Access Compliance Report Public Rights-of-Way (Curb Ramps)

Main Street: WICKFORD_DR		Cross Street: HYDE_PARK_DR		Location:	SE
ADA ID: RPRK211013112226	Ramp Type: Type 4 - Parallel	Initial Pass/Fail: Fail	Overall Compliance: No	Severity Score:	30
Codes/Mitigation Info/Possible Solution			Field Measurements/Component Compliance

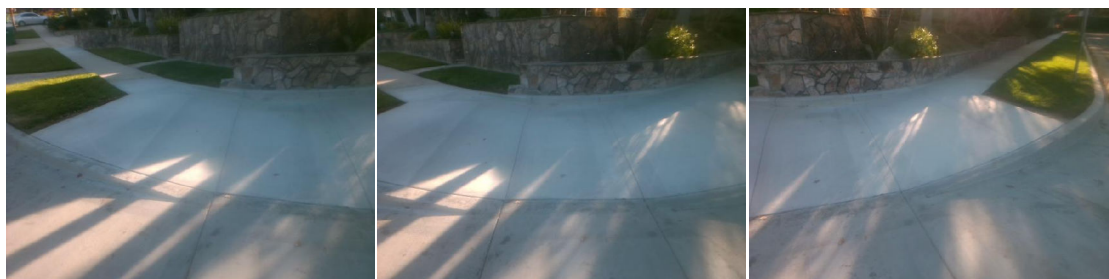
Compliance	Description	Data	Compliance	Description	Data
N/A	Ramp Length LT (in)	93	N/A	Ramp Length RT (in)	94
Yes	Ramp Width LT (in)	120	Yes	Ramp Width RT (in)	118
No	Ramp Run Slope LT (%)	9.3	Yes	Ramp Run Slope RT (%)	7.8
No	Ramp Cross Slope LT (%)	4.8	No	Ramp Cross Slope RT (%)	5.6
N/A	Landing Present	N/A	N/A	DWS Provided	N/A
N/A	Landing Length (in)	N/A	N/A	DWS Contrast	N/A
N/A	Landing Width (in)	N/A	N/A	DWS Length (in)	N/A
N/A	Landing Run Slope (%)	N/A	N/A	DWS Full Width	N/A
N/A	Landing Cross Slope (%)	N/A		DWS Offset Type	N/A
N/A	Landing Movement Obstructed?	N/A	N/A	DWS Offset Left (in)	N/A
	Landing Movement Type	N/A	N/A	DWS Offset Right (in)	N/A
N/A	Landing Shared	N/A			
N/A	Clear Space	Yes			
N/A	Clear Space To Crosswalk (in)	N/A			
N/A	Marked Crosswalk 1	No	N/A	Marked Crosswalk 2	No
	Crossing 1 Direction	NW		Crossing 2 Direction	SW
	Marked Crosswalk 1 Width (in)	N/A		Marked Crosswalk 2 Width (in)	N/A

Remove & Replace Curb Ramp With Two New Directional Ramps or Equivalent.
